CITY OF ALBUQUERQUE

RE: **Bruno Residence**
8001 Fuji Court
Grading Plan
Engineer's Stamp Date 1/13/17 (File: E10D029)

Based upon the information provided in your submittal received 01/13/2017, the Grading Plan is not approved for Building Permit. The following comments need to be addressed for approval of the above referenced project:

ENGINEER'S SEAL	8001 FIJI COURT BRUNO RESIDENCE	DRAWN BY WCW/J
	GRADING AND DRAINAGE PLAN	DATE 1-12-17
		21701-LAYOUT-1-10-17
1/13/17	 <i>Rio Grande Engineering</i> 1606 CENTRAL AVENUE SE SUITE 201 ALBUQUERQUE, NM 87106 (505) 872-0999	SHEET # —
DAVID SOULE P.E. #14522		JOB # 21701

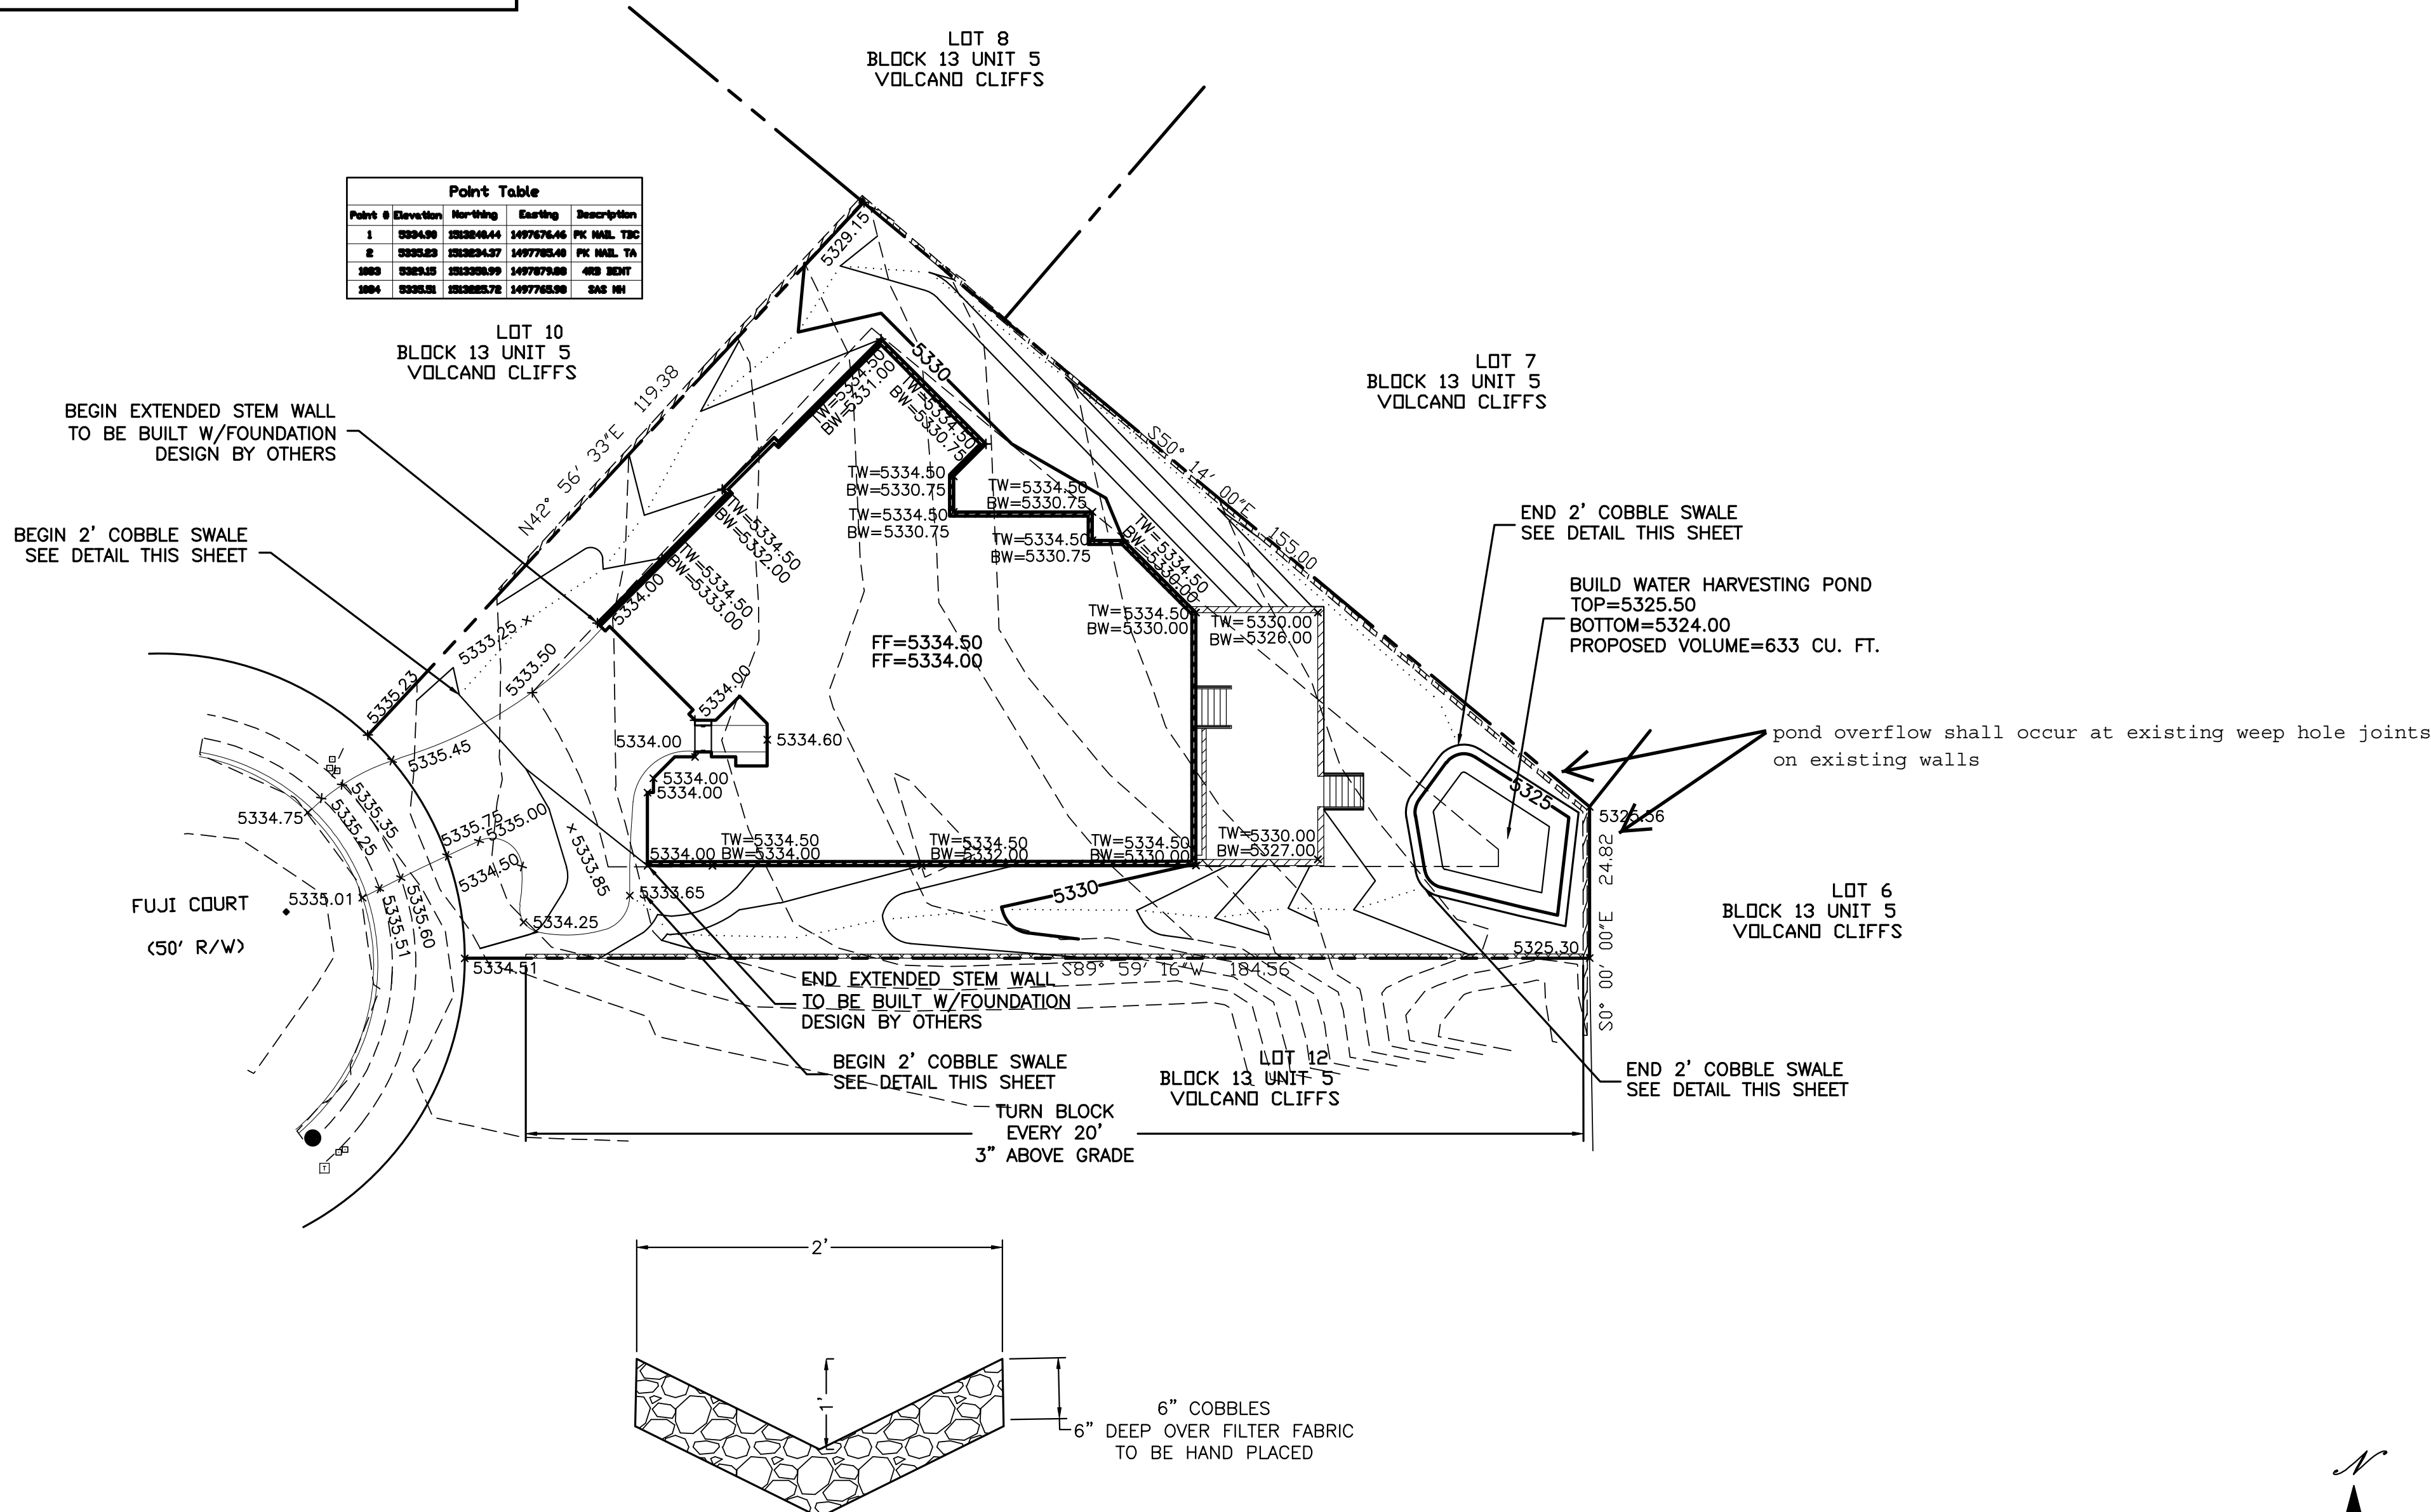
1. For historic flowpaths to adjoining lots, retain at least 50% of the proposed conditions 100-year, 24-hour event. Currently the pond is sized to hold only 633 cubic feet.
2. This site is within Special Assessment District 227, not 226, update the narrative to reflect.
